Safety Evaluation Report

With Open Items Related to the License Renewal of Prairie Island Nuclear Generating Plant Units 1 and 2

Docket Nos. 50-282 and 50-306

June 2009

Figure 4.3-1

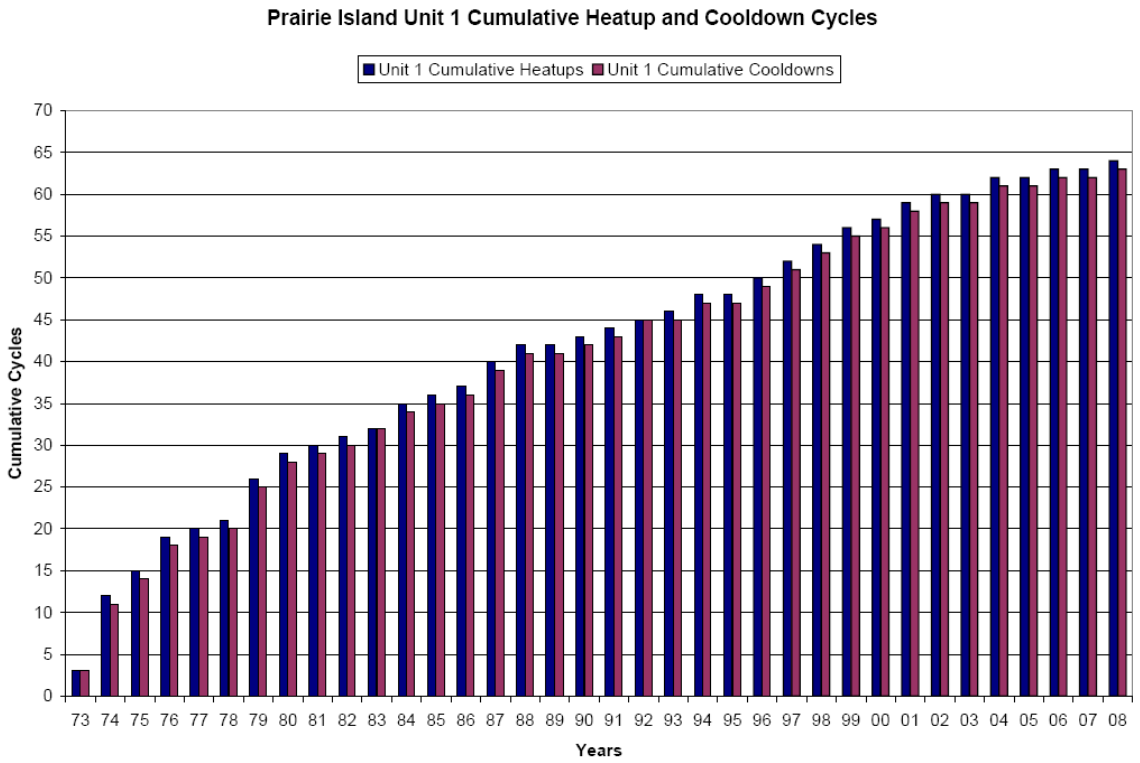
The staff reviewed these histograms and found that the transientoccurrence rates (both heatup and cooldown) are quite constant for Unit 1 since 1980 and for Unit 2 since 1983. This means that for the past 25 years, the PINGP (Units 1 and 2) plant operation has been quite steady. The applicant made its cycle projections based on the slope of a straight line connecting the time of the plant startup (1973 for Unit 1 and 1974 for Unit 2) and the last data point, 2008. It is clear from Figures 4.3-1 and 4.3-2, that the slope used by the applicant for making cycle projections is significantly greater than that of the average of the past 25 years. As expected, the slopes of event occurrence (i.e., the rates) during the first few years (5 to 7 years) are higher than the averages for both heatups and cooldowns. This means that the basis of projections that the applicant used is conservative and therefore, the staff found it to be acceptable.

Based on its review, the staff's concern on the transient event monitoring is resolved because the applicant provided the information requested and the information validates the PINGP fatigue management program and the applicant's assumption for the number and severity of transients.
